DIABLO CANYON NUCLEAR PROJECT
JOB # 7177
SPEC # 8711

Crack in Steam Generator Feedwater
Nozzle to pipe weld
(Generator No. 1-2)

DISCREPANCY REPORT

D.R. NO. 3366 Rev. II
ISO. NO. 500146
UNIT NO. 1
CODE NO. 4/A

(JOINT DETAIL)
FOR RE-WELD
OF FW 212

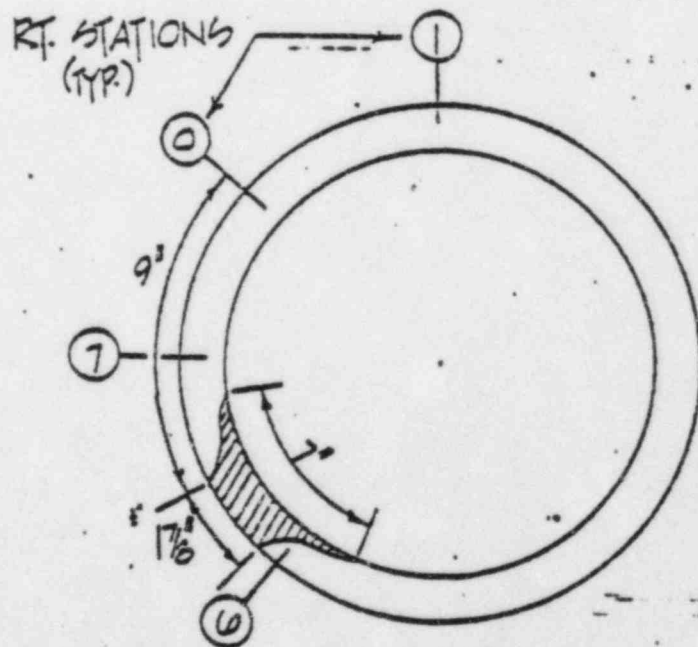
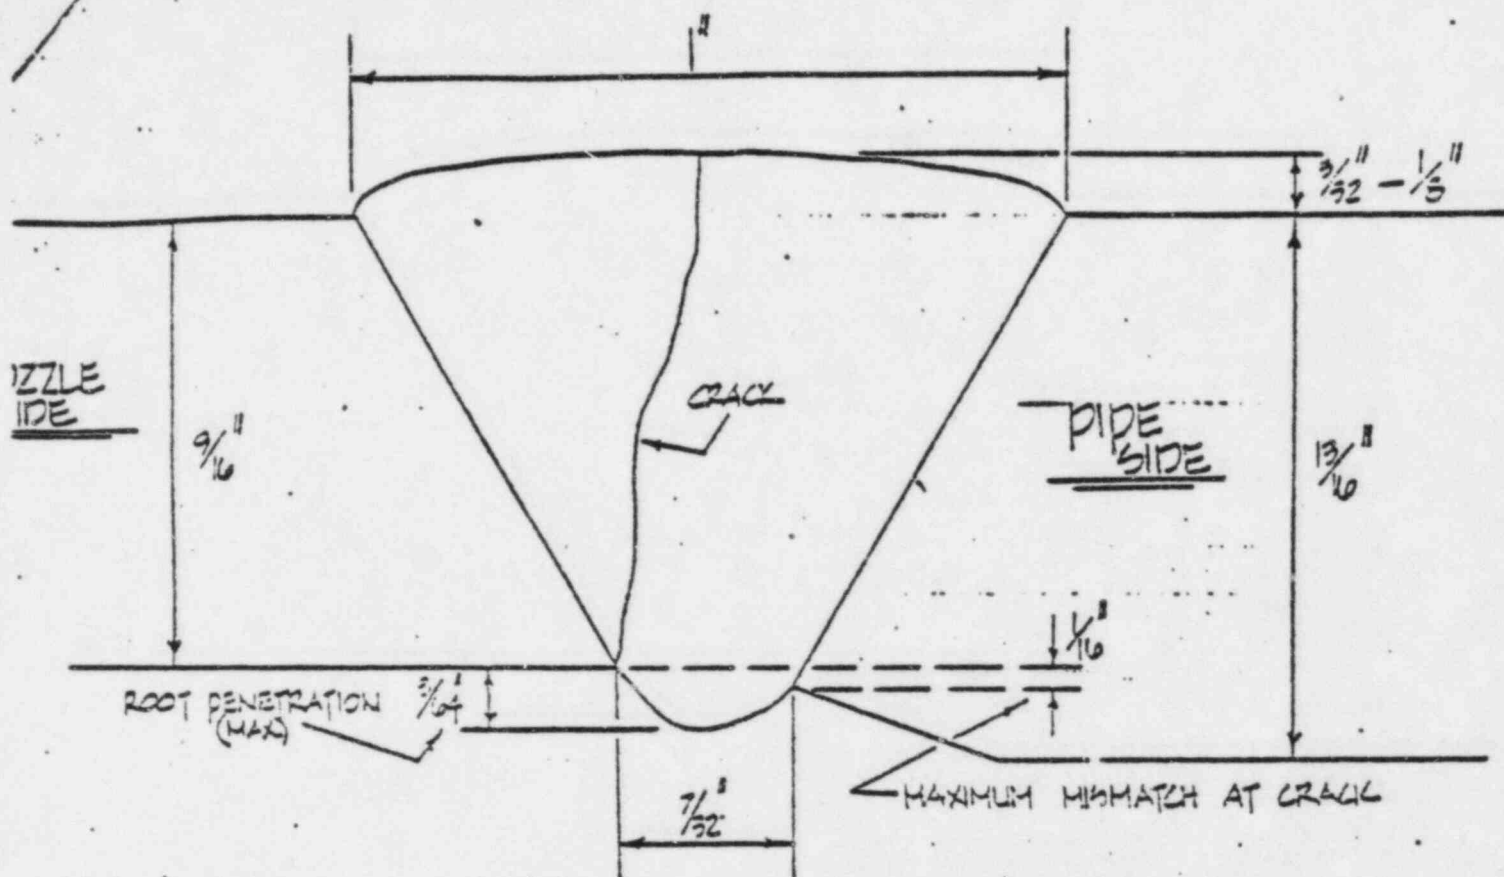
DISCREPANT ITEM: F.W. #212, Line K16-555-16-IV, Steam Generator 1-2, Nozzle to pipe

A leak was detected by P.G.&E. in F.W. #212 (Pipe--Steam Gen. 1-2 Nozzle).
Leak occurred during Hot Functional Testing March 17, 1977. Line pressure was approximately 90psi, temperature approximately 330°F.

- A. Cut out weld and reweld.
- B. Prior to weld cut-out:
 1. Map weld area with U.T. to determine size and location of indication.
 2. X-ray for an analysis.
 3. Remove weld material with indication for further analysis.
 4. Cut out spool 580 (F.W. #503 to 212).
- C. Reweld procedure: (Rewritten)
 1. Weld F.W. #503 using procedure 4/5 and 88/89
 2. Weld F.W. #212 using procedure 200 or 204 (See Attached Sheet #2 for additional requirements).
 3. Install soc-o-let on new spool using F.W. #411 so vent can be reinstalled.

1. Preheat to 250°F minimum.
2. Maintain interpass at 250°F minimum, 500°F maximum until weld is complete and post weld heat treatment begins.
3. M.T. root pass; ESD-250.
4. R.T. after root and 2 layers weld added ESD-207. Repair if required and re-R.T. before completing weld.
5. Post weld heat treat at 1100°F minimum, 1150° maximum hold for 1 hour minimum, AT temperature..
6. Following post weld heat treatment, perform R.T.; ESD-207 and M.T.; ESD-209.
7. P.G.&E. will perform U.T. of final weld and maintain records.

SECTION THRU PIPE NEAR F.W. 147

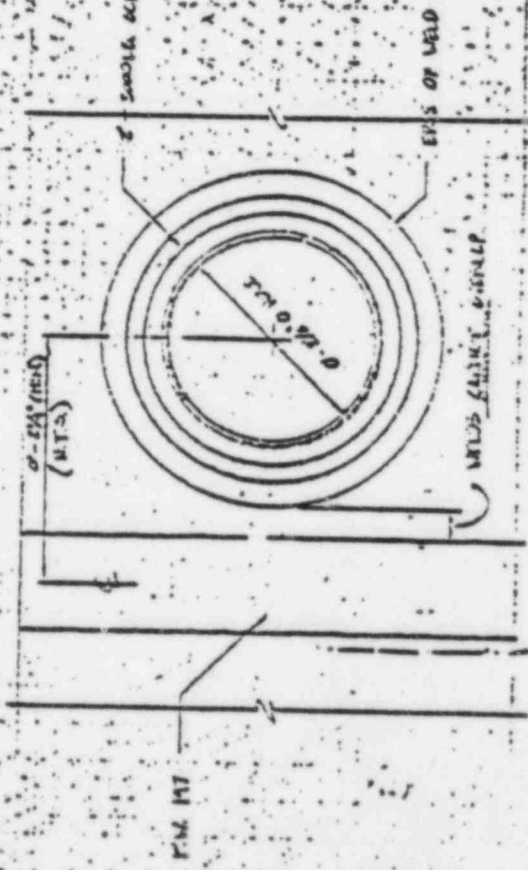
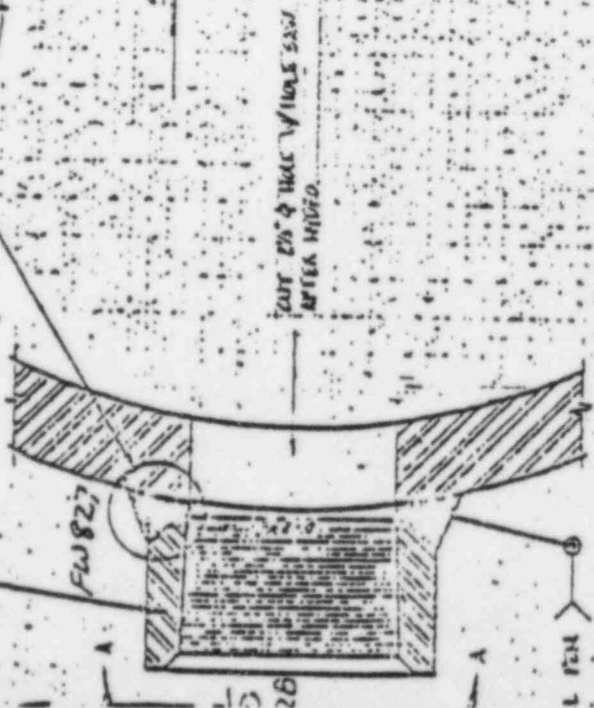
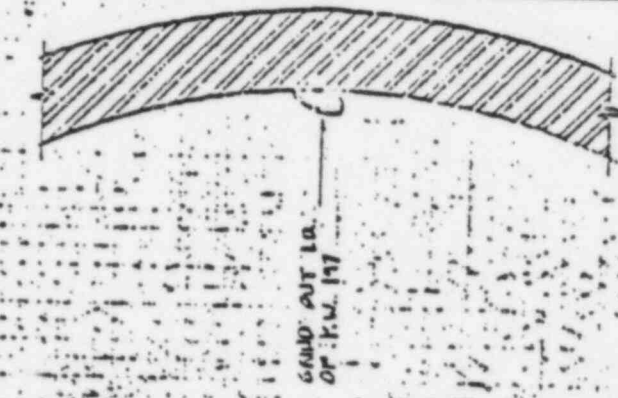
DISCREPANT ITEM: F.W. #197, Line K16-554-16-IV, Steam Generator 1-1 Nozzle to pipe

The review revealed a questionable indication in F.W. #197 on the feedwater lead to Steam Generator 1-1. The indication appears to be a burn through which contains linearly oriented voids. The accompanying radiographic report accepted the weld but did not indicate the presence of the burn through. Further investigation revealed that a second set of radiographs, shot at a later date, exist. This set also shows the burn through which was recorded on the radiographic report as acceptable (see copies attached).

To eliminate the possibility of a potential problem at a later date, it is recommended that the burn through be removed.

1. Weld a 2" threaded coupling to the pipe as shown on the attached sketch using weld procedure 88/89 or 92/93. (FW # 927).
2. M.T. per ESD-209.
3. Post weld heat treat the weld - ESD-218.
4. Perform a hydrotest on the weld prior to drilling into the pipe.
5. Following satisfactory completion of the hydrotest, cut the hole through the pipe wall with a hole saw (Ref. ESD-230) NOTE: Additional reinforcement of 2" opening is not required per P.G.&E. calculations
6. Using an extended shaft grinder with a cone shaped rock, grind the burn through flush with the pipe surface.
7. Radiograph the area to assure complete removal of unacceptable indications.
8. Install threaded plug and seal weld (F.W. #828).
